Service Bulletin

NVA110B #1
Revised December 2023

SAFETY RECALL

2022 NVA110B Speedometer Cable Replacement

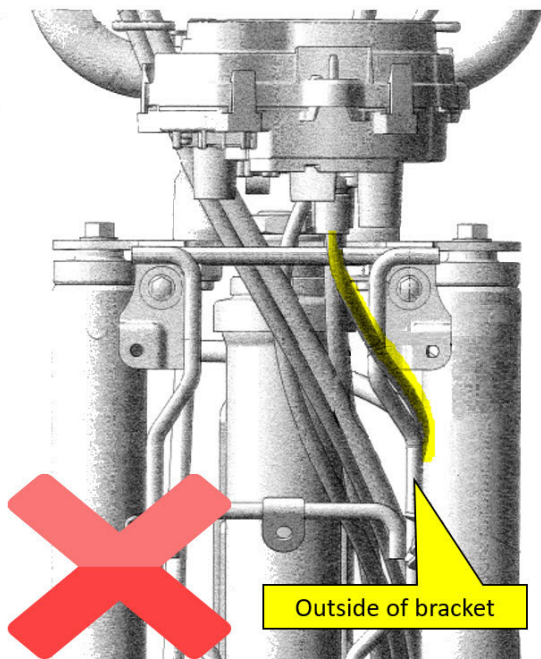
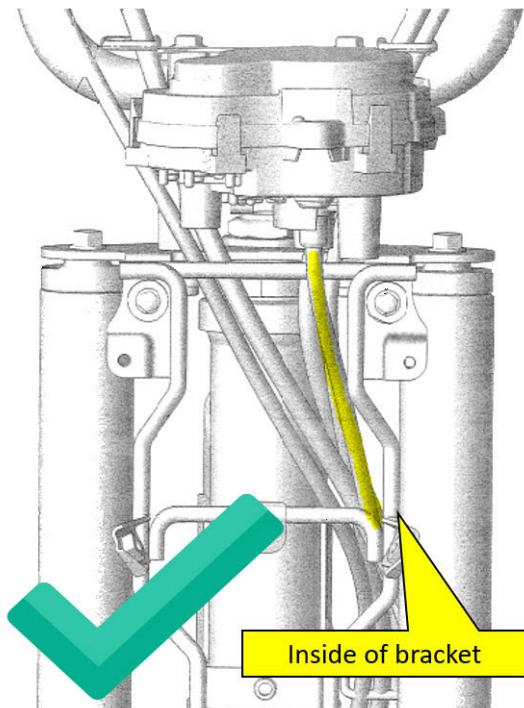
Honda is launching a **SAFETY RECALL** on **CERTAIN 2022 NVA110B** motorcycles to replace the speedometer cable. An improperly routed speedometer cable may result in a speedometer malfunction which can affect the rider's judgment to ride safely, increasing the risk of a crash or injury.

6. Install the new speedometer cable in reverse order of removal. Follow the routing instructions shown below.
